RE: Response to Joint Agency Request for Additional Information, Waste Rock Pile Workplan Design Package and 2021 Cover Performance Review, Cunningham Hill Mine Reclamation Project, MMD Permit No. SF002RE and NMED DP-55

Re: Response to Request for Additional Information
Waste Rock Pile Workplan Design Package and 2021 Cover Performance Review
Cunningham Hill Mine Reclamation Project
MMD Permit No. SF002RE and NMED DP-55

CUNNINGHAM HILL WASTE ROCK PILE IMPROVEMENTS

SHEET 2 OF 5
 DWG NO. G-1
 JOB NO.
 DB22.1087

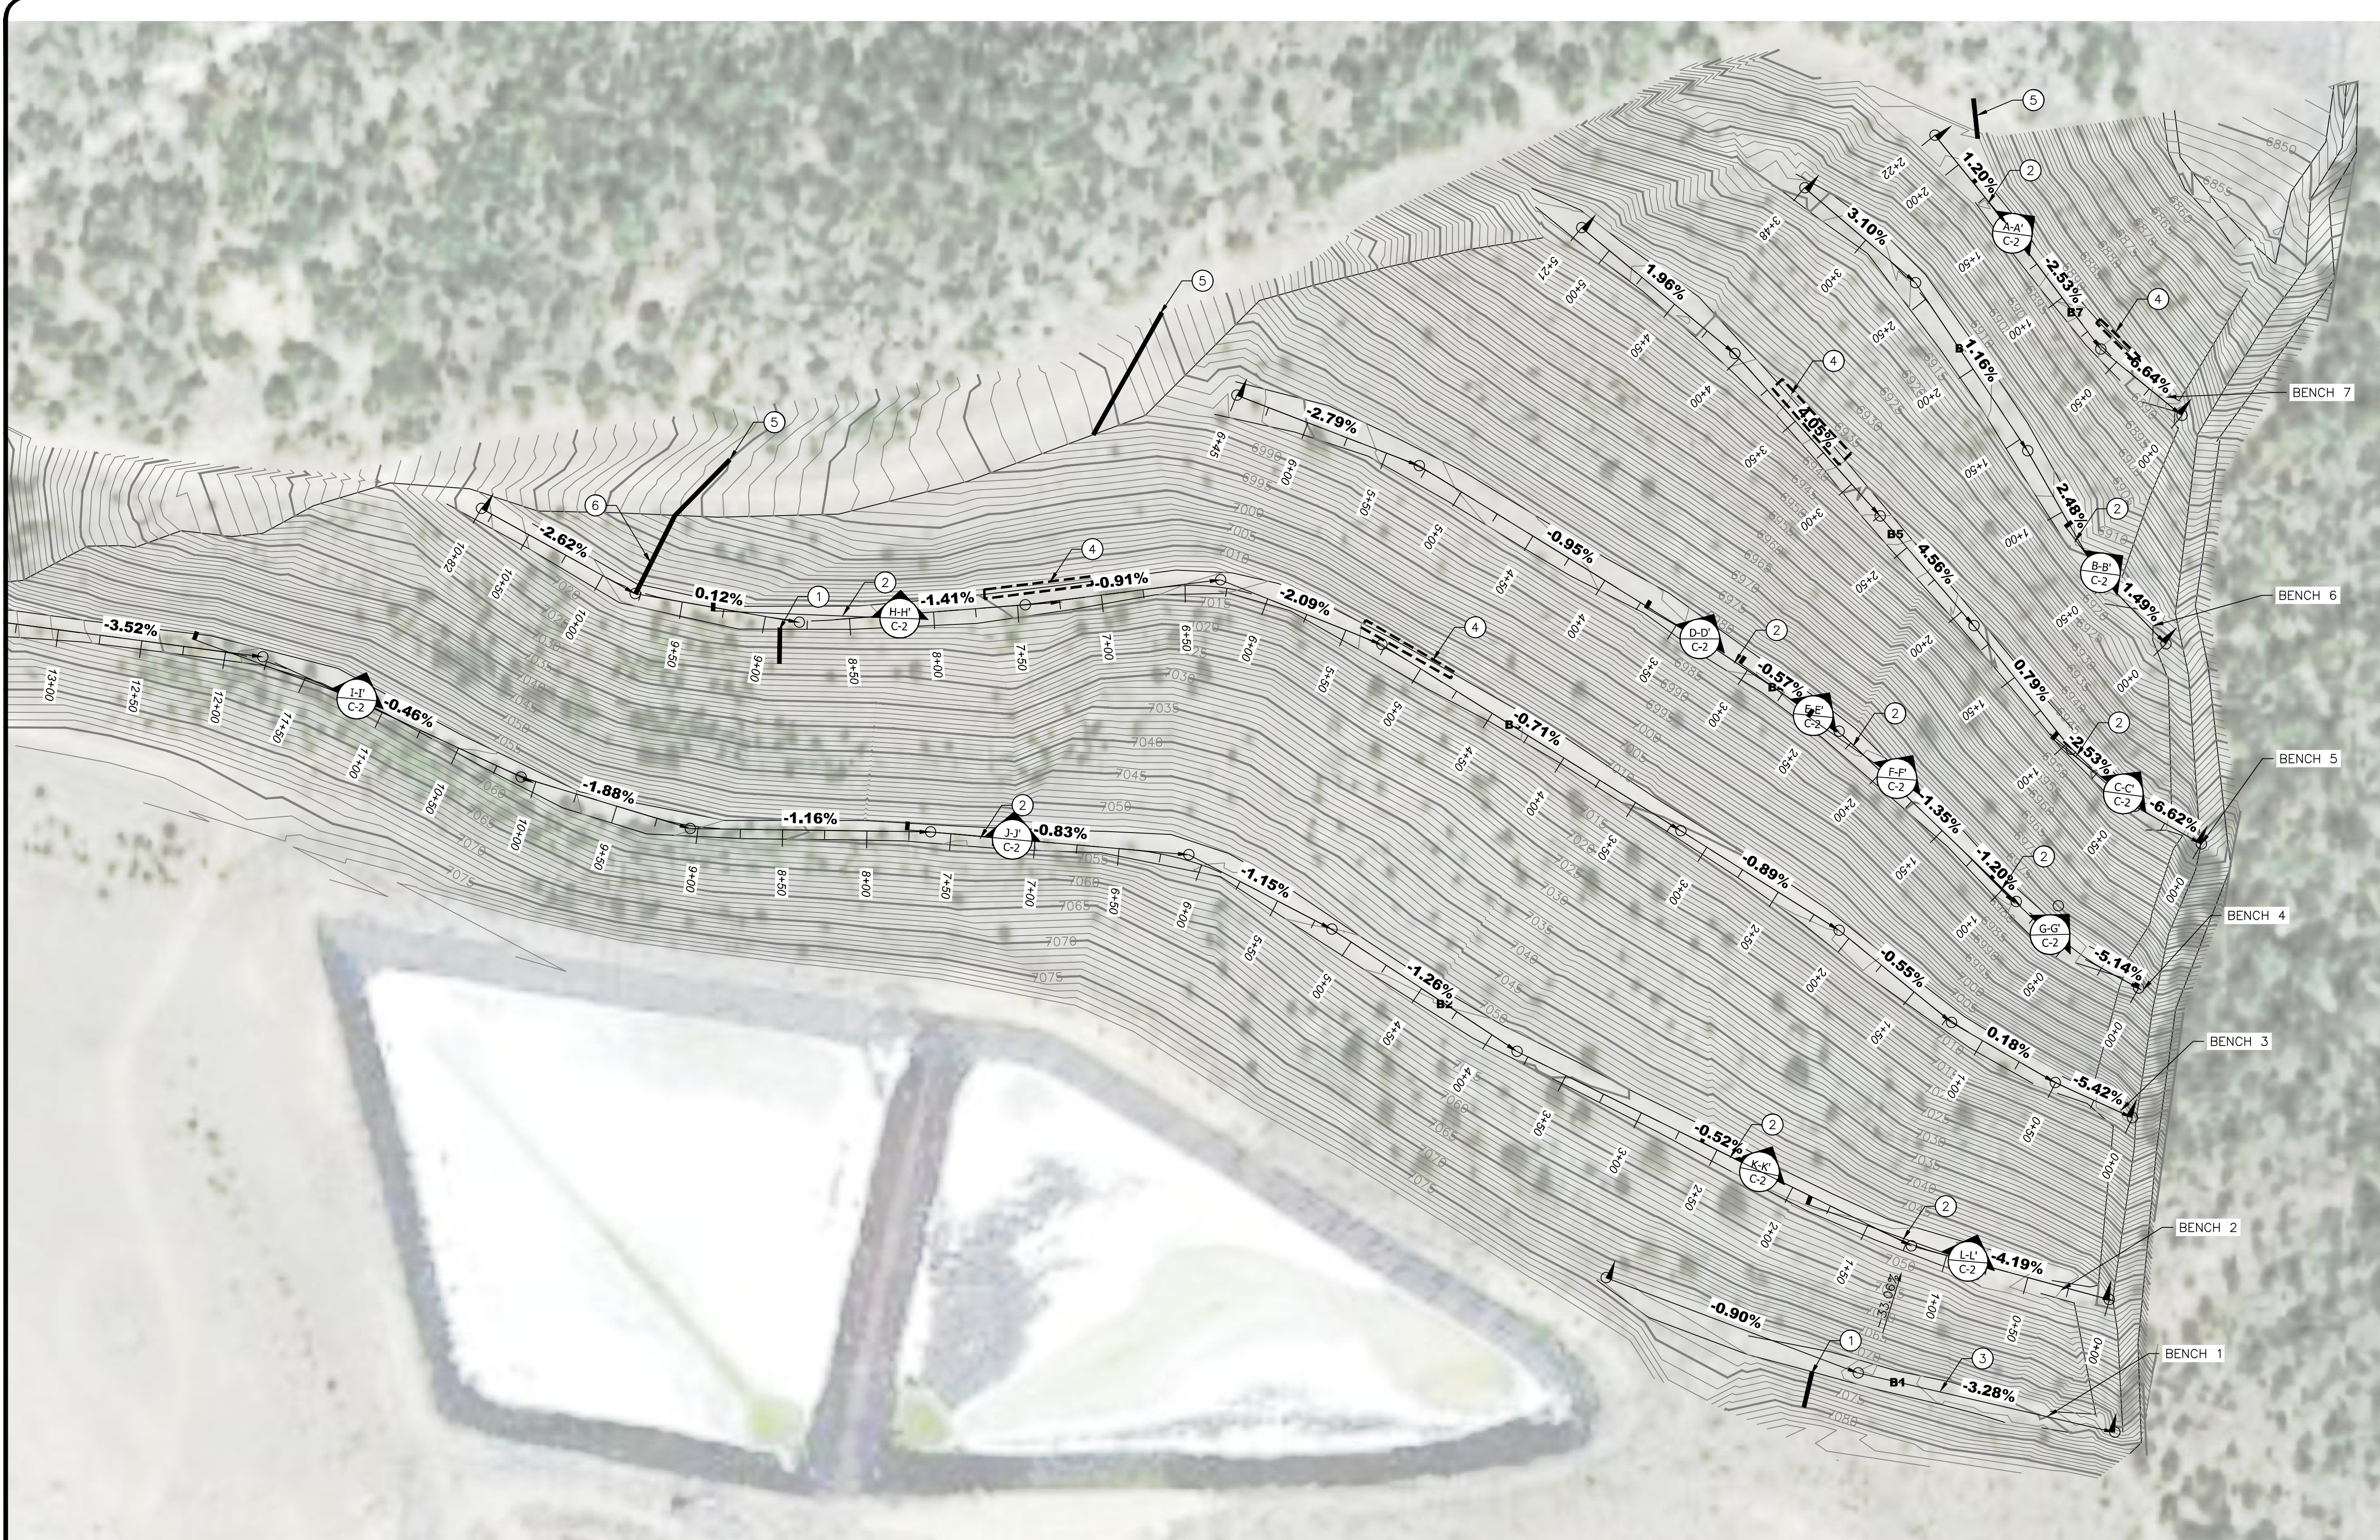
4. *IFC Drawings, sheet 2 of 5, Design Survey Letters O and P. The General Construction Notes mention NAD-27 central zone coordinate system and NGVD 29 vertical datum with no ability to validate this information. The entire project is largely based on success repair of slopes and thickness to fill material. Provide an explanation of how the construction fill and grade will be validated in a specific coordinate system for the as-built report.*

The improvement areas will be located in the field using an optical builders' level, measurements based on the IFC drawings, and visual observations of the terrain. The construction contractor will use their level to help achieve the specified slopes for the improvement areas (Sheet 4 of 5 of the IFC Drawings) and desired cuts and fills.

Survey control is in the process of being reestablished at the site after previous controls were destroyed. A surveyor has been contracted to establish control in the New Mexico

State Plane coordinate system using a NAVD-88 vertical datum. Once the proposed improvements are complete, they will be surveyed to support the preparation of a topographic map for the as-built report and validate the improvements.

SHEET 3 OF 5
 DWG NO. C-1

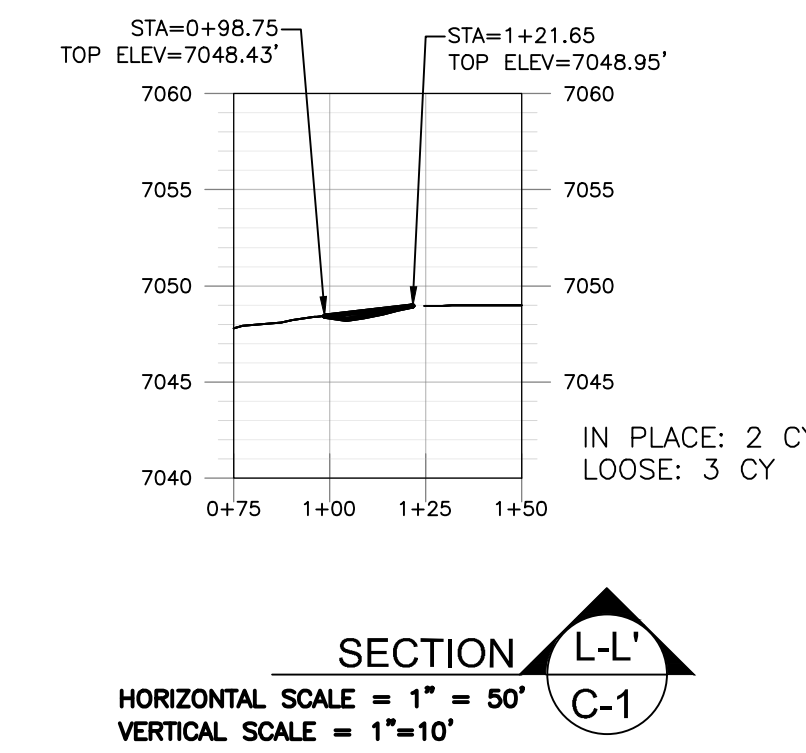
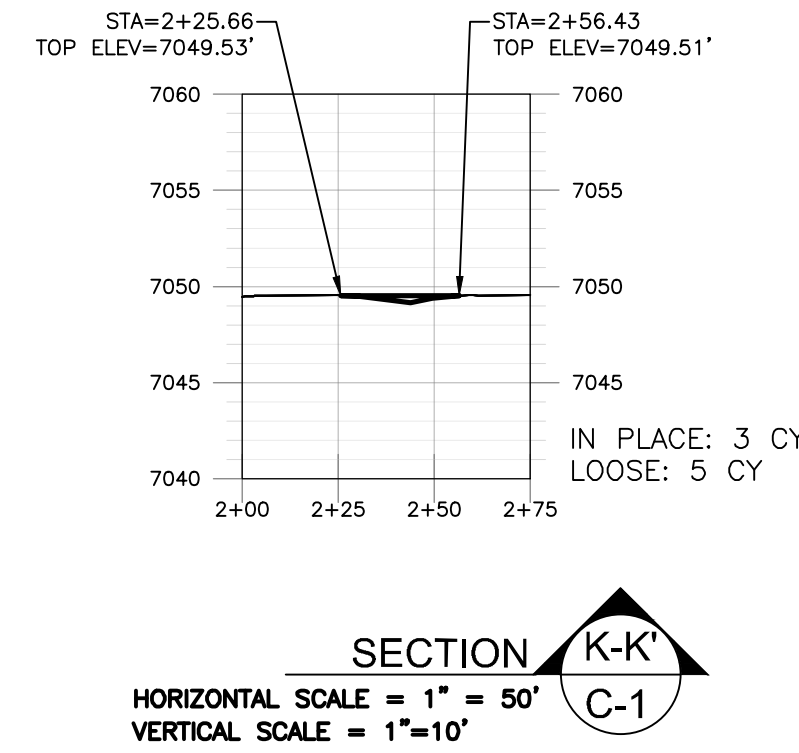
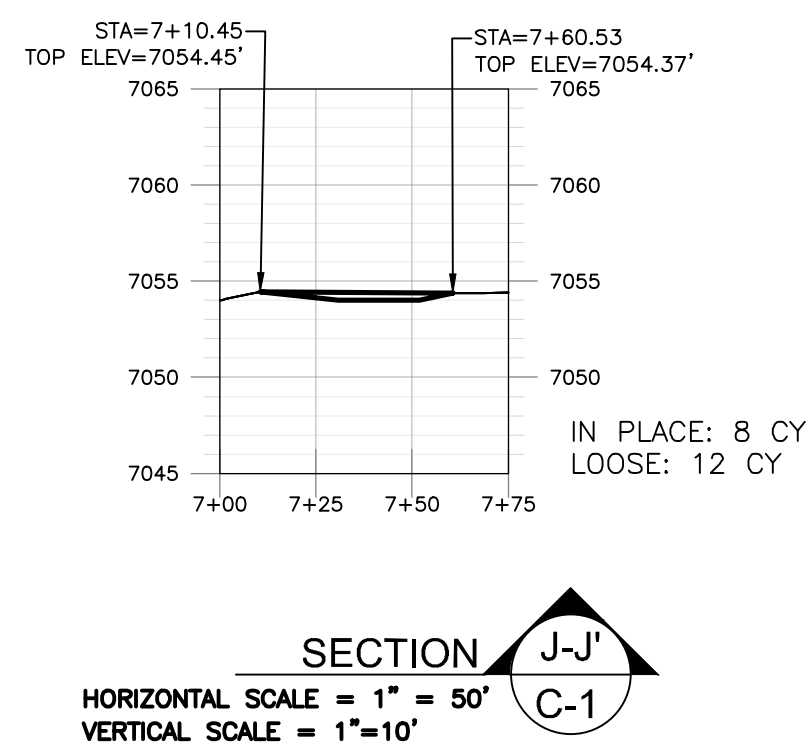
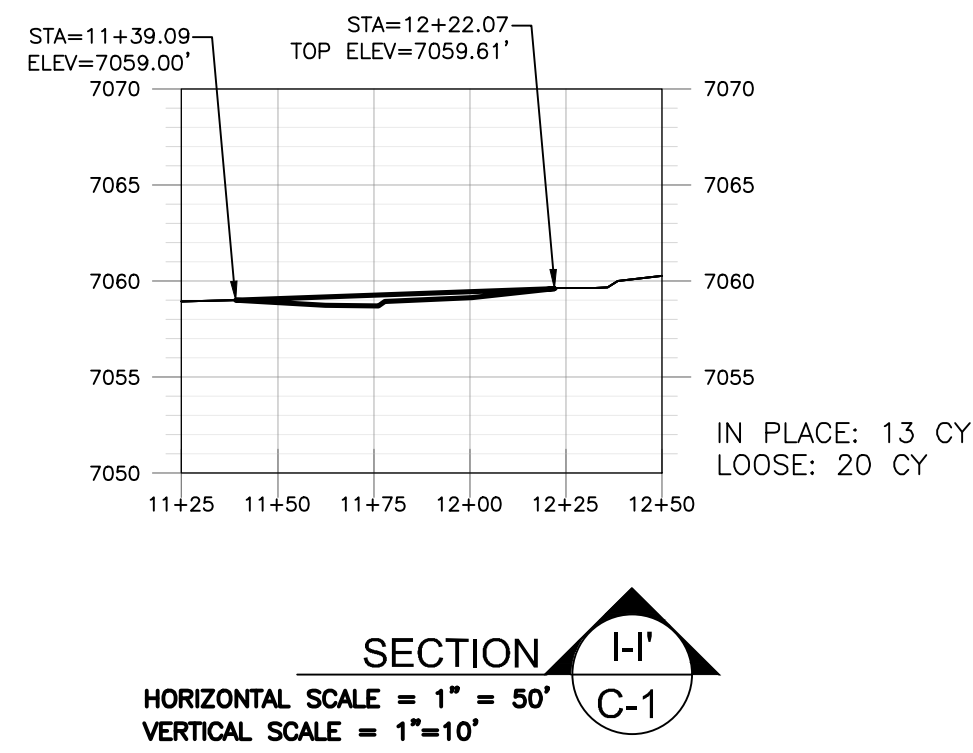
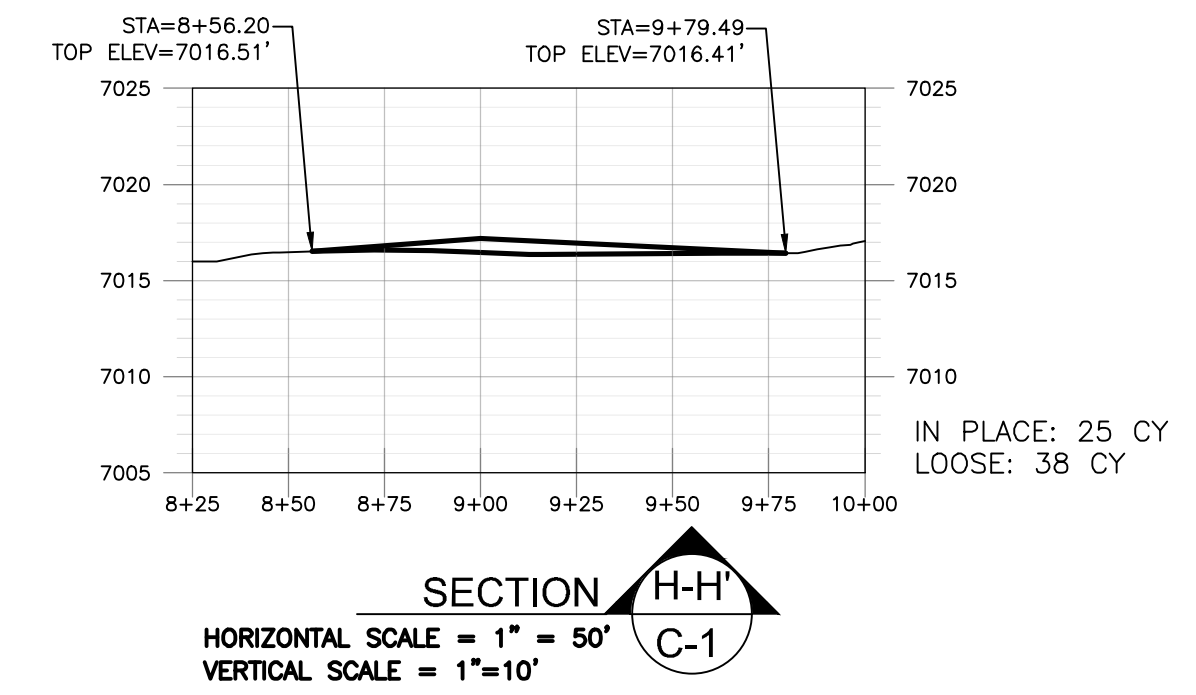
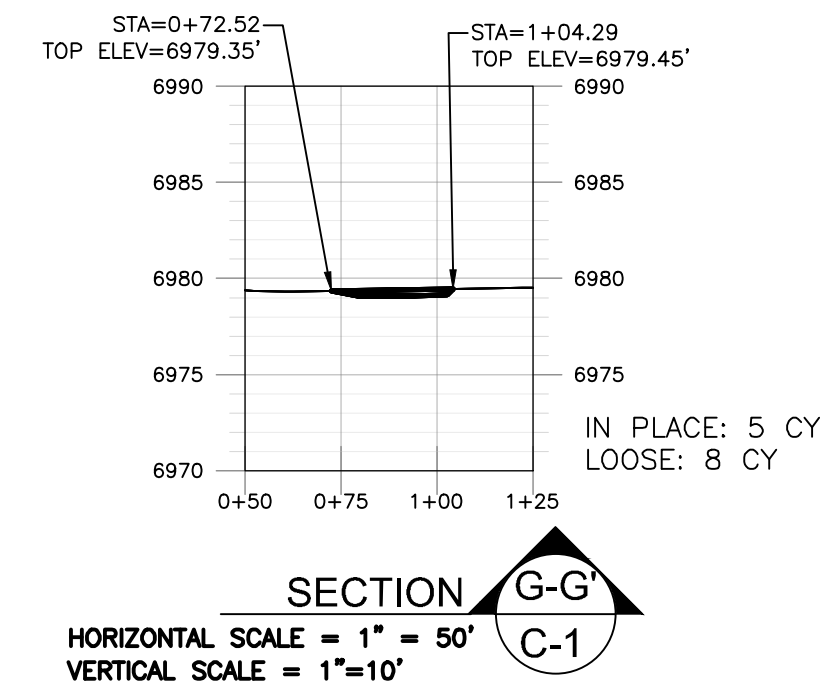
1. *Page 2, Grading of Benches and IFC drawings, sheet 3 of 5. There are no clear design criteria for the percentage slope on the benches in the Engineering Drawing Issued for Construction (IFC Drawings) in Attachment 1. The IFC Drawing shows numerous bench slope percentages ranging from -6.82 to 3.10 with numerous reaches less than 1 percent, especially on Bench 3. The changes in slope may continue to cause infiltration and deposition of sediment, which will further alter the grade on the benches. The benches need to be designed to convey stormwater off the reclaimed waste rock pile and limit infiltration. Based on the agencies' experience, a minimum of a uniform 2-5% grade on benches is recommended. Please provide a percentage grade expected to be achieved to move water off the benches in addition to any intermediate channels to be constructed across the waste rock pile to reduce infiltration on the benches. In addition, additional design details are needed to show how the benches will tie into the East and West Groin channels.*

5. *IFC Drawings, sheet 3 of 5. The numbers for slope percent are partially or completely obscured at H-H', G-G', and E-E'. Make the numbers visible.*

6. *IFC Drawings – sheet 3 of 5. Provide clarification what the percentages of bench slopes mean with respect to a slope achieved during construction. In other words, are they preconstruction survey measurements of actual slopes or expected changes in slope following fill placement?*

The range in bench slope percentages shown in Sheet 3 of 5 of the IFC drawings represents pre-construction site conditions. Design criteria are shown in the profiles on Sheet 4 of 5. A primary goal for this project is to restore the slopes, in accordance with the original design, along areas of the benches where depressions or shallow slopes have developed and are evident. The proposed improvements are consistent with the original designed bench slopes shown in the document titled *As-Built Construction Report for the Cunningham Hill Waste Rock Storage Facility North Slope Bench Regrade and Coversoil Project* (Schafer and Associates, 1996). The improvements will promote positive drainage toward the east and west groins, while minimizing disturbance to the cover, particularly the healthy and

established vegetation. The proposed improvements do not affect how the benches tie into the east and west groin channels.

Achieving a uniform 2 to 5 percent grade would result in an unnecessary and significant disturbance to the successfully revegetated cover, which would likely restart the 12-year performance period. For instance, between stations 0+50 and 13+00 on Bench 2, there is an existing elevation difference of 15 feet. In order to achieve a minimum of 2 percent slope across this bench, an additional 10 feet of fill would be required at station 13+00. Similarly, on Bench 3, between stations 0+50 and 10+00, there is an existing elevation difference of 9 feet. In order to achieve a minimum of 2 percent slope across this bench, 11 feet of fill would be required at station 10+00. Adding this amount of fill or rerouting the benches to achieve 2 to 5 percent slopes would significantly alter the existing configuration of the cover and cause substantial disturbance. The proposed improvements will eliminate shallower slopes and depressions, promoting positive drainage to the groin channels.

These slopes have been made visible in the revised IFC drawings (Attachment 1).

Bench slopes shown on Sheet 3 of 5 of the IFC drawings are pre-construction, existing slopes.

SHEET 4 OF 5
 DWG NO. C-2

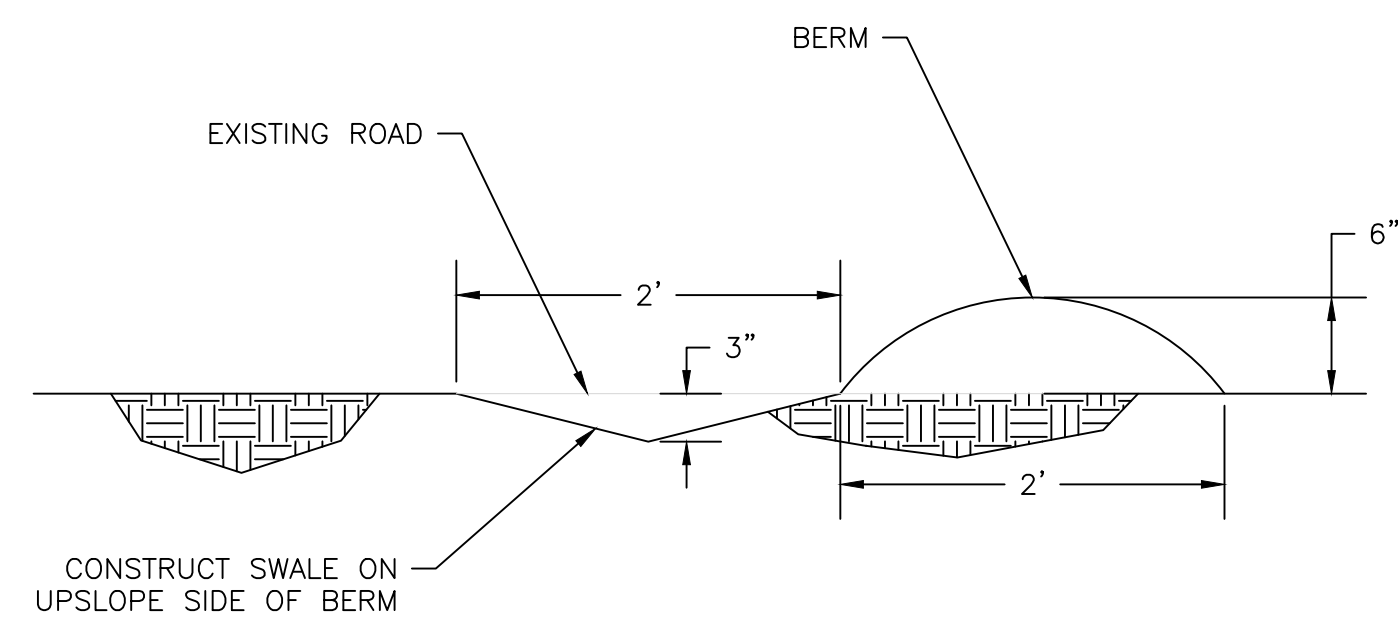
2. *Page 2, Grading of Benches, Attachment – IFC Drawings Section F-F'. The text mentions one area requiring cut at F-F' on Bench 4. This area has an estimated thickness 12-18 inches of cover before the cut. What will the cover thickness be at F-F' after the cut is completed?*

Results from the cover soil thickness survey completed by Meridiam Partners, LLC (dated December 22, 2021) show between 22 and 24 inches of cover in the location of F-F' on Bench 4. In order to meet the design grade, a maximum of 3.5 inches of soil will be removed, resulting in a cover thickness of 18.5 to 20.5 inches in this location.
